Response to Sio Silica’s Denial of the Motion to delay the Hearing until completion six material actions and section 35 indigenous consultations

D.M. LeNeveu, B.Sc. (hons. physics), B.Ed., M.Sc. (biophysics), former member of the Canadian Society of Safety Engineering

Oct. 31, 2022

Figure 2. Bru 95-2 CWS permitted injection well south of Vivian 2019.
 Illustration is by D. M. LeNeveu. Well information report was from Manitoba Groundwater.

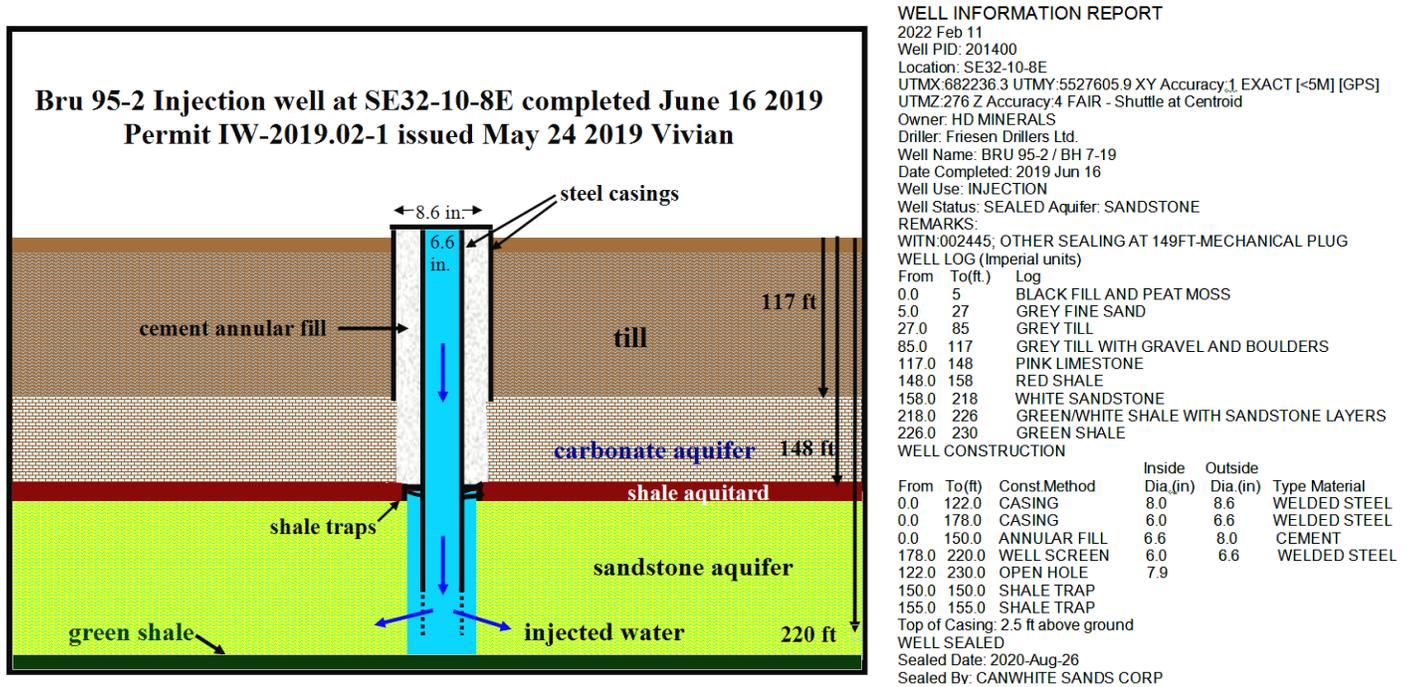
The wells Bru-95-2 and Bru 95-3 do not conform to the Sio Silica design for extraction wells given in supplementary filing of June 2, 2022, Silica Extraction Method and illustrated in figure 5. Only a single casing in Bru 95-2 and Bru 95-3 extends into the sandstone. A single casing extending into the sandstone could not have been used for simultaneous water re-injection and sand extraction. An outer casing was installed into the carbonate with the annular spacing sealed. The sealing date of the annular spacing can not be determined. Manitoba Groundwater issues one combined well information report for extraction and sealing even though for the sealing dates reported that are much later than the completion date, two reports are required. At the time of sand extraction the annulus between the inner and outer casing could have been open. In this event, according to the well design, water could have been re-injected into the carbonate formation only which is not allowed by regulations. Thus valid full-scale field tests with re-injection that conforms to the Sio Silica EAP sand extraction well design could not be performed on these two wells. This leaves only well Bru 92-8 available for full-scale filed tests with water re-injection. The design of well Bru 92-8 is illustrated in Figure 4.

Figure 5. Sio Silica EAP well extraction design

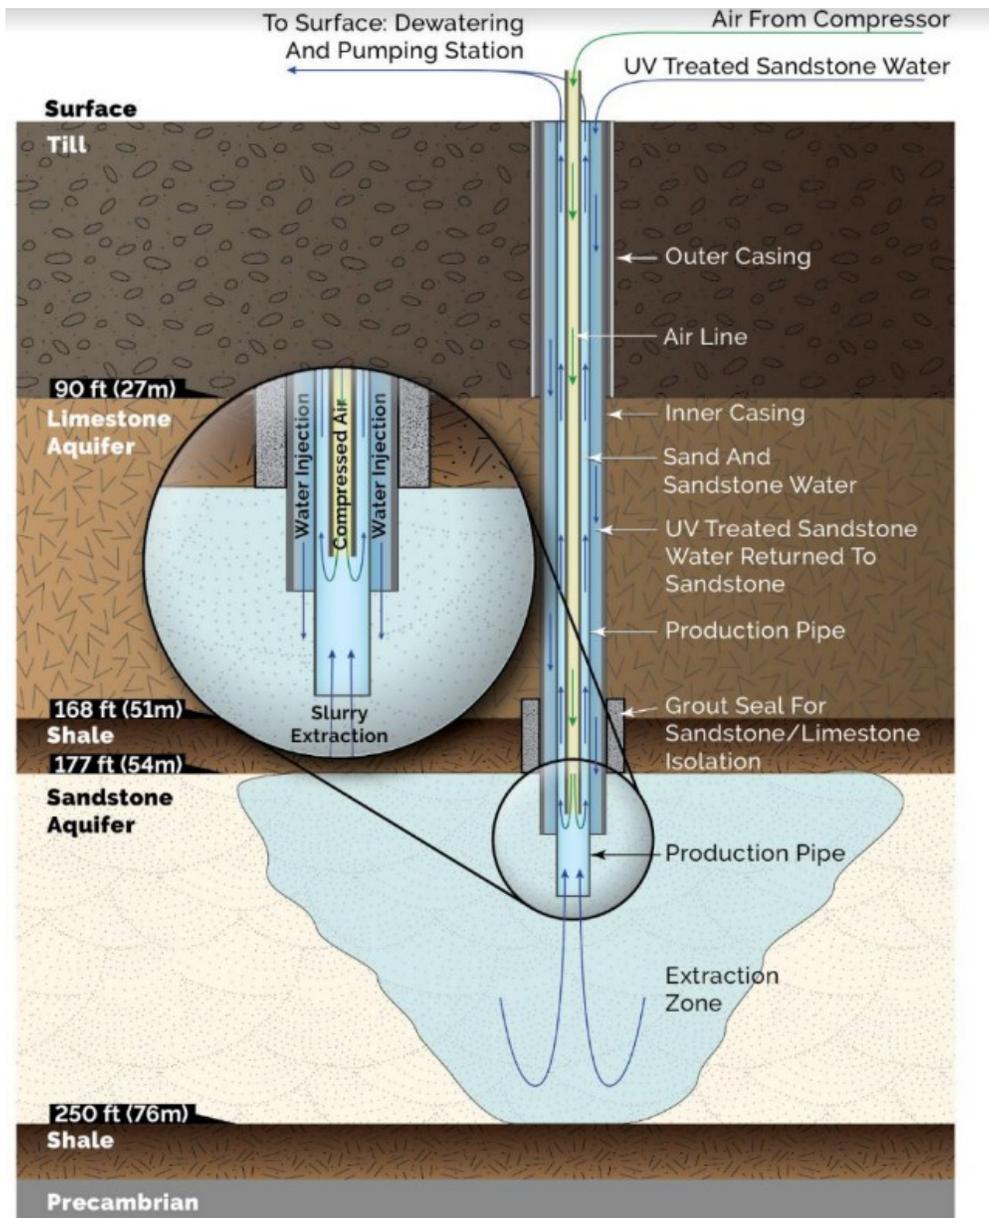
Well Bru 92-8 does not conform to the Sio Silica EAP sand extraction well design shown in figure 5.

There is no production casing extending into the sandstone formation for Bru 92-8. The Sio Silica design states that the production casing is removable. It is possible that the production casing was removed and therefore not shown in the well information report. In an email Manitoba Groundwater reported that the only extra casing penetrating deep into the sandstone was a casing around the well drill that was removed immediately after the well drilling was completed. The text of the email response of Sept.22, 2022 is given below.

Therefore it appears not only was no production liner used, Bru 92-8 was eventually used solely for water re-injection. Use of an extraction well solely for re-injection does not conform to the Sio Silica extraction design and protocol. Without a production tube extending into the sandstone, process wastewater could not have been re-injected into the aquifer by gravity as per the Sio Silica well cluster extraction protocols and as shown in figure 5.

The re-injection of process water has always been one of the major critical problems associated with the air-lift extra method. Sio Silica in its so called full-scale field test has never demonstrated and documented in the EAP the extraction method illustrated in figure 5. This fundamental operational problem of re-injection of process wastewater has never been resolved.
